Work Order ID 75589

Item Name: Replacement Float Skidtube

DART SERVICE INSTRUCTION

TO AMEND INSTALLATION INSTRUCTIONS IIN-D412-742 REV. D
AND INSTRUCTIONS FOR CONTINUED AIRWORTHINESS ICA-D412-742 REV. 3

**FIGURE 1: CHANGE AT FORWARD SADDLE LOCATION
WITH DSI-9517-011 KIT INSTALLED**

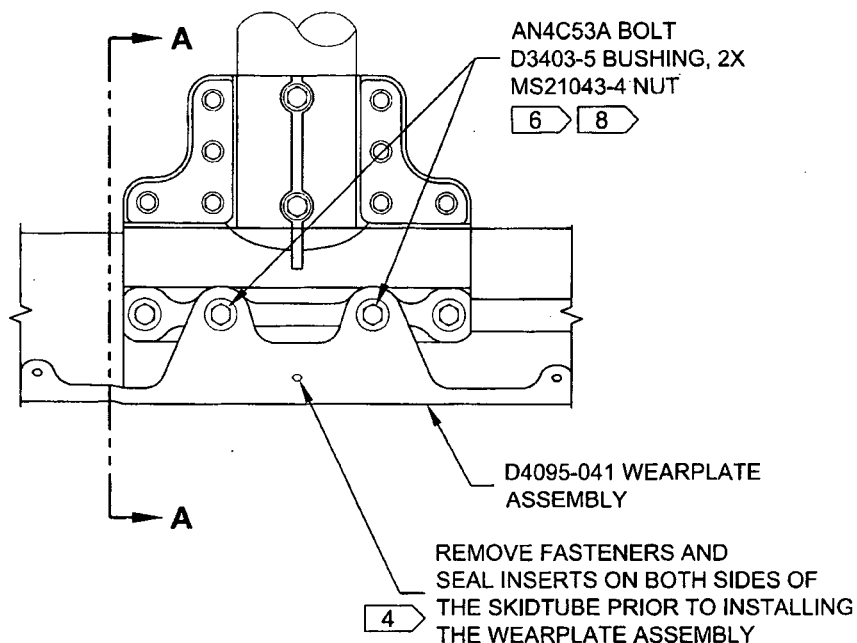
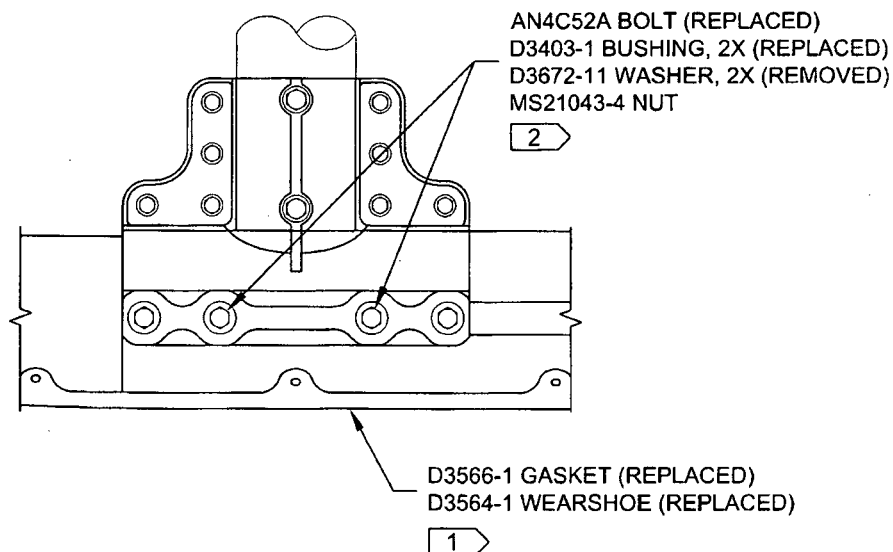
The purpose of this service instruction is to introduce an alternate wearplate installation for the D412-742-011/-013 Skidtube Installations. The new DSI-9517-011 Wearplate Kit consists of new wearplates destined to replace existing D3564-1/-3 Wearshoes and D3566-1/-3 Gaskets. The components in the DSI-9517-011 Wearplate Kit are as defined in the parts list on sheet 4 of this service instruction.

Replace D3564-1/-3 Wearshoes and D3566-1/-3 Gaskets with D4095-041/-043 Wearplates Assemblies as follows:

1. Remove existing D3564-1/-3 Wearshoes and D3566-1/-3 Gaskets per Item 32.6.1 of ICA-D412-742. It might be necessary to loosen the aft end of D3564-5 Wearshoe and D3566-5 Gasket.

2. Remove qty.(4) AN4C52A Bolts, D3403-1 Bushings, and qty.(8) D3672-11 Washers as indicated in Figures 1 and 2 of this service instruction.
3. Inspect the skidtube and saddles per Chapter 5 of ICA-D412-742.

4. Seal existing inserts located on both sides of the skidtube in area shown in Figures 1 and 2 of this service instruction using Sikaflex -241/-291 or Proseal 890 or MIL-S-8802 Class 2B sealant.

5. Locate the DSI-9517-011 Wearplate Kit as shown in Figure 1 and 2 of this service instruction.
6. Transfer drill qty.(2) Ø0.438 hole from the skidtube/saddle to the D4095-041/-043 Wearplates Assemblies. Deburr. Touch up finish per Item 5.2.14 of ICA-D412-742 as required.

7. Install the DSI-9517-011 Wearplate Kit using the same AN3C hardware as shown in ICA-D412-742. Torque to 15-25 in-lbs (1.7-2.8 N-m).
8. Install D3403-5 Bushings and AN4C53A Bolts in lieu of D3403-1 Bushings and AN4C52A Bolts removed at step 2 above. Ensure that the nuts on the AN4C Bolts are on the inboard side of the skidtube. Torque to 50-70 in-lbs (5.7-7.9 N-m).

SECTION A-A

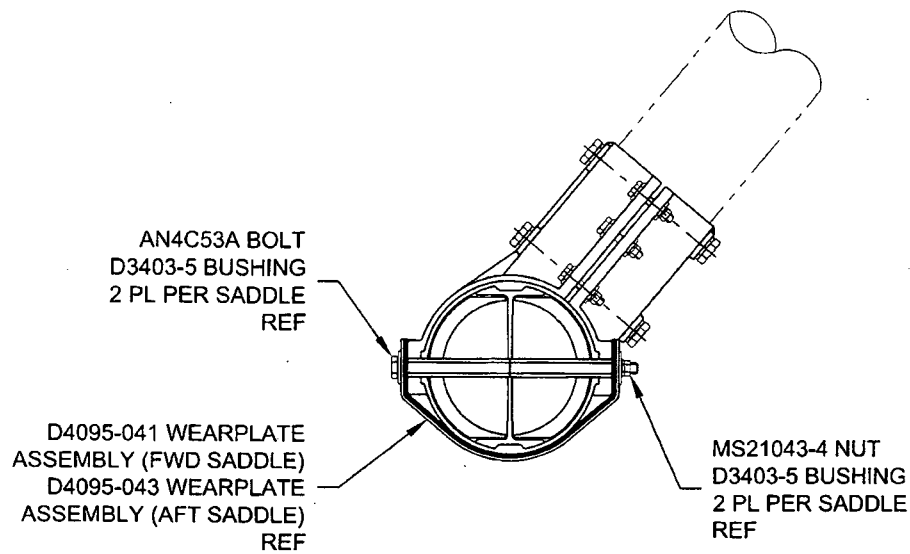
THE PARTS LISTS IN SECTION 32.15 OF ICA-D412-742 (PAGES 53 AND 55) AND SECTION 5.1 OF IIN-D412-742 (PAGES 16 AND 17) ARE AMENDED AS FOLLOWS WHEN OPTIONAL DSI-9517-011 KIT IS INSTALLED:

3		10	AN3C6A	BOLT (REMOVED QTY.2)
4		4	AN3C7A	BOLT (REMOVED QTY.4)
5		38	AN960C10L	WASHER (REMOVED QTY.6)
21A	1		D4095-041	WEARPLATE ASSEMBLY
22A	1		D4095-043	WEARPLATE ASSEMBLY
46	8		D3403-1	BUSHING (REPLACED QTY.4 WITH D3403-5)
46A	8		D3403-5	BUSHING (REPLACES QTY.4 D3403-1)
49	4		AN4C52A	BOLT (REPLACED QTY.4 WITH AN4C53A)
49A	4		AN4C53A	BOLT (REPLACES QTY.4 AN4C52A)
53	8		D3672-11	WASHER (REMOVED QTY.8)

3		12	AN3C6A	BOLT
4		8	AN3C7A	BOLT
5		44	AN960C10L	WASHER
21A		1	D3564-1	WEARPLATE
21B		1	D3564-3	WEARPLATE
22A		1	D3566-1	GASKET
22B		1	D3566-3	GASKET
46	16		D3403-1	BUSHING
49	8		AN4C52A	BOLT
53	16		D3672-11	WASHER
